RECORD OF CORRESPONDENCE
&
MEETING MINUTES
FOR
GROVERS AVENUE
STORM DRAIN LATERAL
FCD No.: 93-21

MM/CSSA Project No.: 8156.001

DATE 2/9/95	JOB NO.
ATTENTION Bruce Friedhoff	
RE Groves Ave Lateral 90% Review Comments

MINIMUM TRENCH WIDTH
 O.D. + 4' FOR PRECAST
 PIPE OR BOX.
 IN TRENCH BOX

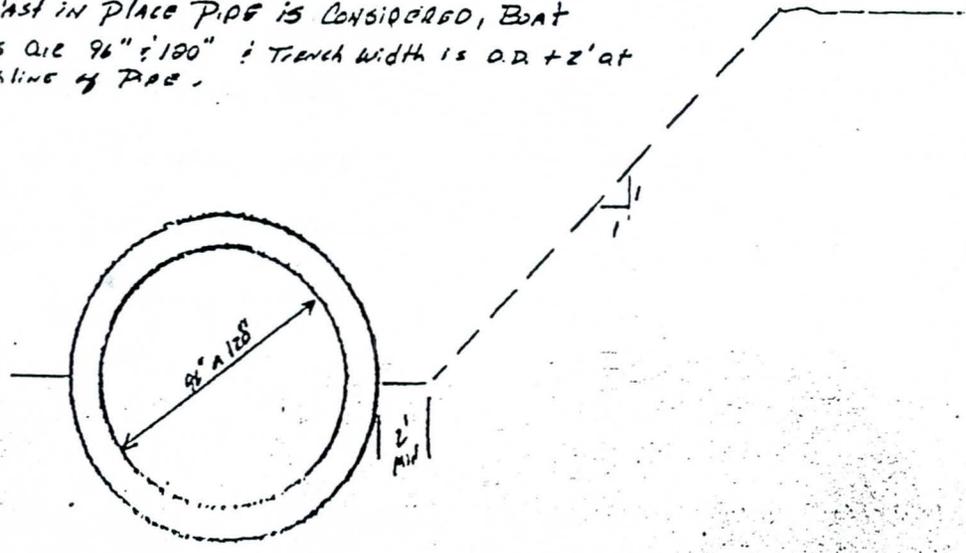
OPERATOR: _____
I suggest relocation of 6" waterline
and moving SD toward sewer,

NOTE: IF CAST IN PLACE PIPE IS CONSIDERED, BOX AT
 SIZES ARE 96" & 120" & TRENCH WIDTH IS O.D. + 2' AT
 SPRINGLINE OF PIPE.

SUBJECT STORM DRAIN LOCATION / TYPE CONDUIT

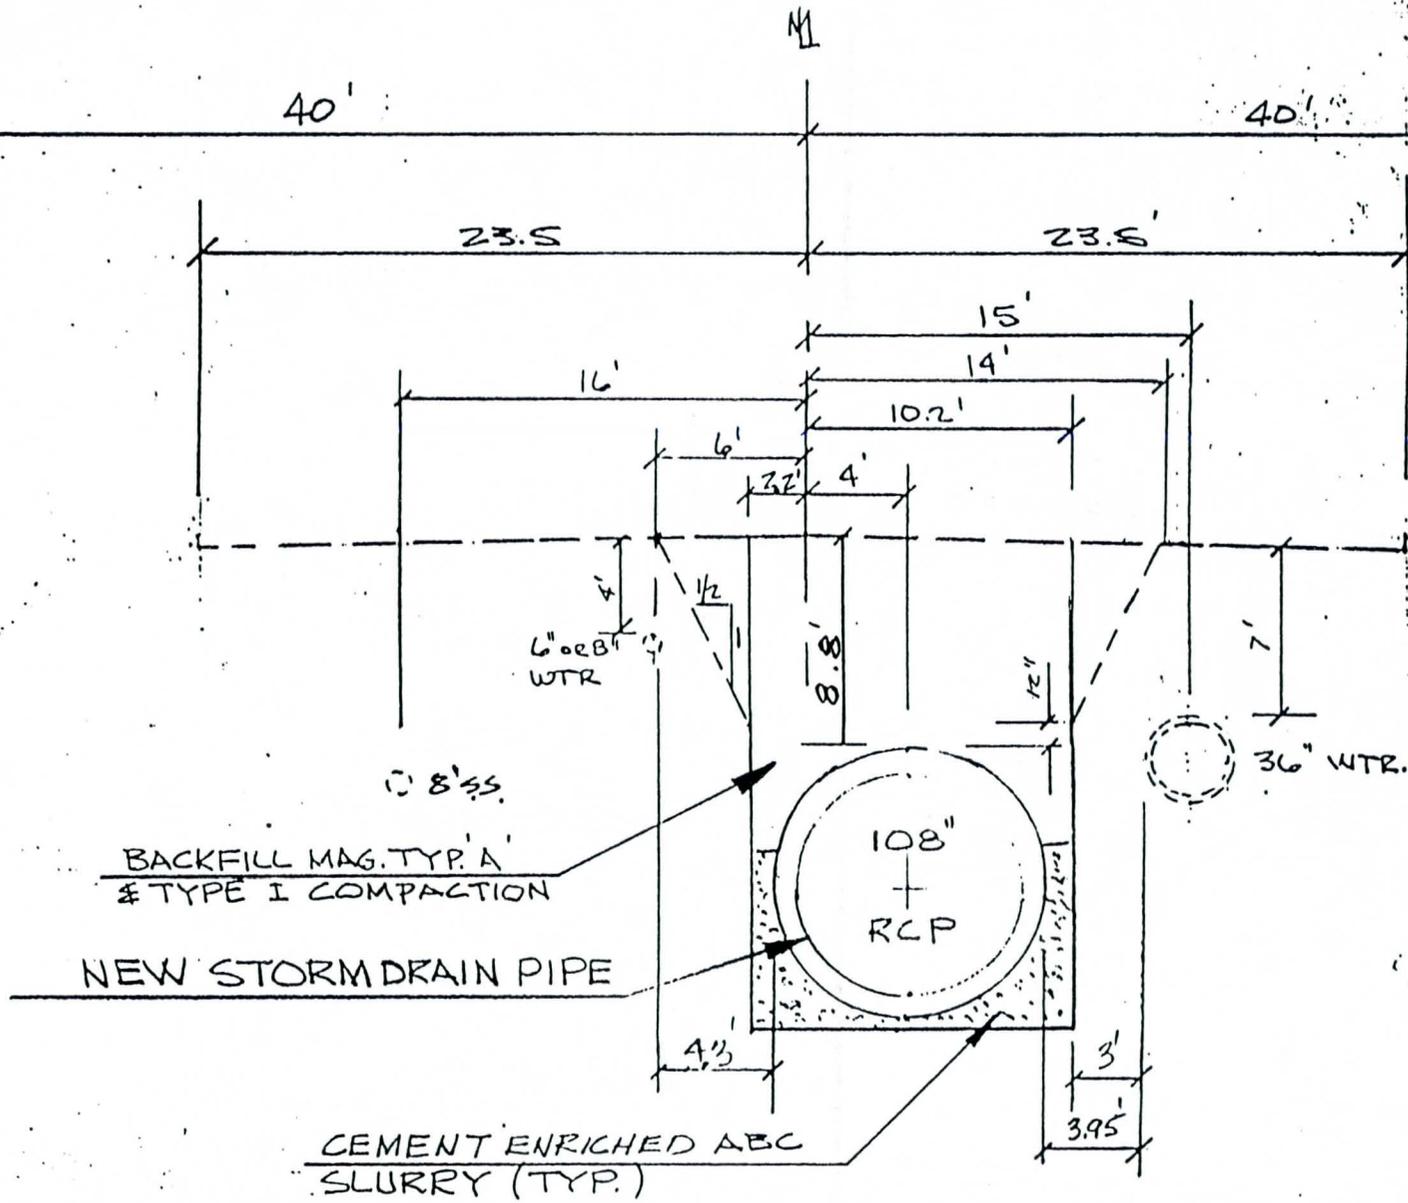
JERRY WAS SOME WHAT CONCERNED ABOUT THE WATER LINE. HE DOES NOT HAVE ANY PREVIOUS EXPERIENCE WITH OPEN TRENCHES IN THIS AREA. SUGGESTED REQUIRING PRECAST 8' X 8' BOX (EASIER & FASTER TO WORK WITH) ALLOW ONLY 300'-500' OF TRENCH OPEN AT ONE TIME. ALSO NOTE THAT "CONTRACTOR IS TO PROTECT 36" W.L. IN PLACE AS REQUIRED."

ACTION REQUIRED OR TAKEN SUGGESTED MOVING 1'-2' NORTH - CLOSE TO THE 6" & 8" THEY WOULD BE EASIER TO PROTECT.

SAID IF WE COULD GET 8' X 8' TO THE NORTH THE 84" SHOULD BE NO PROBLEM @ THE 4' OFFSET. THE CITY ENG FROM NESA WAS IN THE OFFICE WITH JERRY AND AGREED WITH THE PRECAST 8' X 8' BOX AND LIKED THE ENRICHED SLURRY TO 1' ABOVE BOX. — USE SOME WITH OUR PIPE.
